**ELECTRICITY INDUSTRY
(WHOLESALE ELECTRICITY
MARKET) REGULATIONS 2004**

WHOLESALE ELECTRICITY MARKET RULES

AMENDING RULES

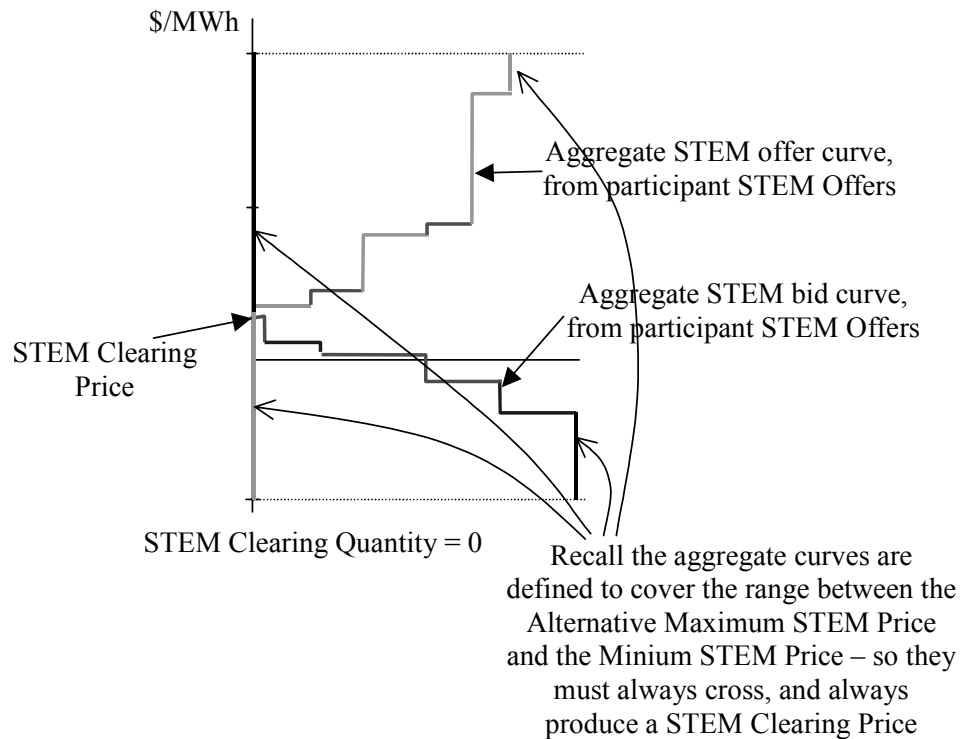
- (1) Delete the existing clause 6.9.3 and replace it with the following:
 - 6.9.3. Subject to clause 6.9.4, the IMO must determine STEM Offers and STEM Bids for each Market Participant for each Trading Interval in accordance with Appendix 6 using the valid STEM Submissions and Bilateral Submissions relating to that Trading Interval.
- (2) Delete the existing clause 6.9.4 and replace it with the following:
 - 6.9.4. Where the IMO has recorded in accordance with clause 6.3B.8 that a Market Participant has not made a STEM Submission for a Trading Interval the IMO must not determine STEM Offers, STEM Bids or MCAP Price Curves for that Market Participant in that Trading Interval.
- (3) Amend clause 6.9.8 by replacing the box text from “Example 4” with the following—

The IMO can clear the market using these generated STEM Offers and Bids. The diagram below shows the STEM being cleared.

Even though no quantity has cleared, the STEM still produces a price that reflects the marginal cost of energy around the bilateral quantities—in this case the price a generator was willing to pay to reduce its generation below the level of its bilateral contract and instead supply the contract with energy purchased in the STEM (although no such energy was actually purchased).
